Application for Disposal Works Construction Permit

453 MONTAGUE ROAD

Date: February 2, 1989

This is to notify you that Filios Enterprises, Inc. has inspected the septic system installed

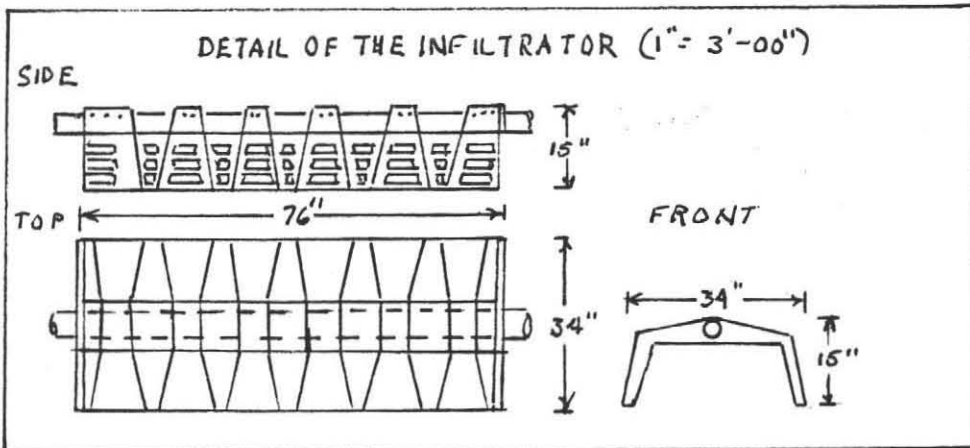
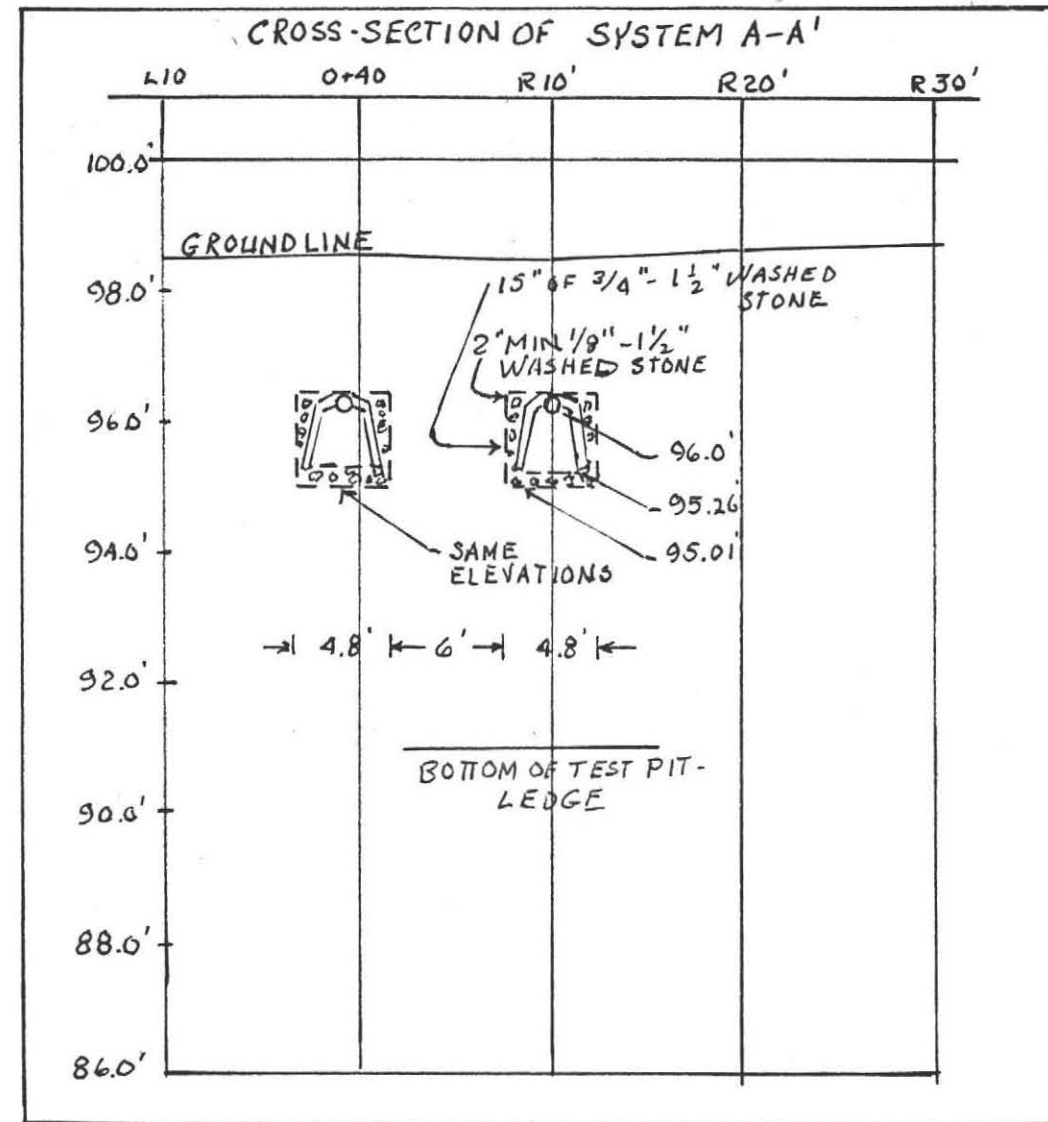
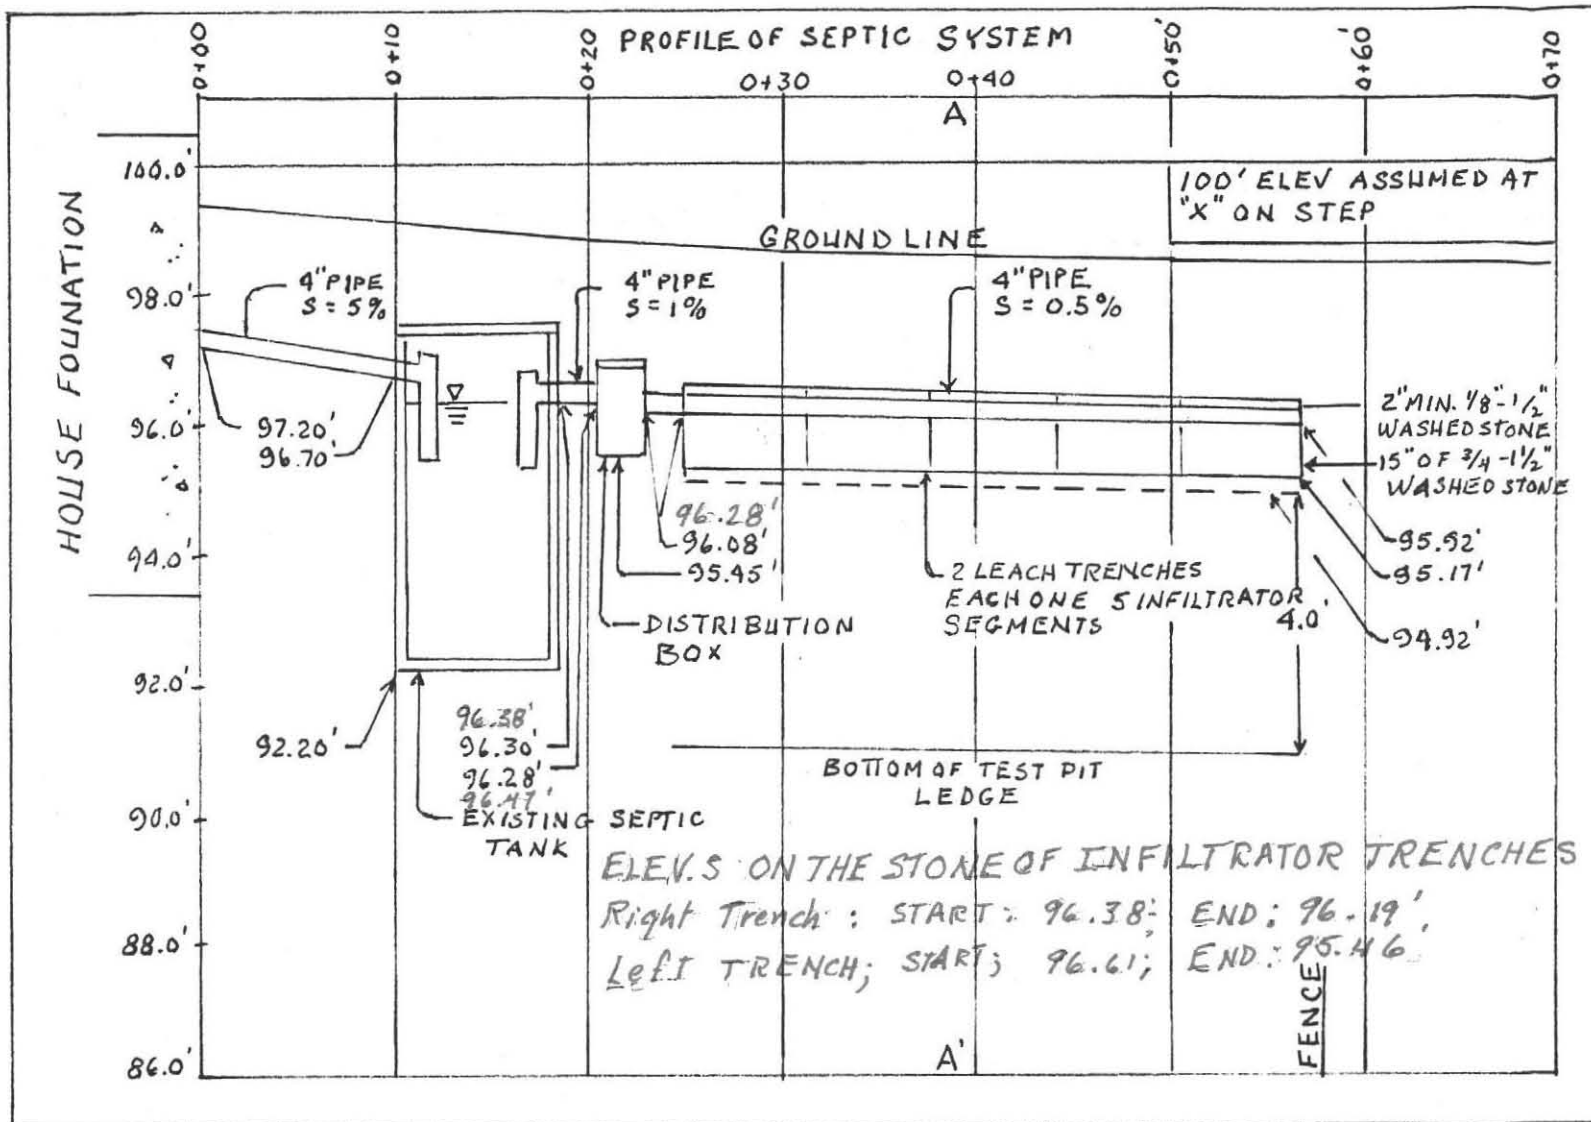
Exceptions:

The elevations of the "as-built" septic system vary from these of the design as shown in red on the copy of the profile enclosed.
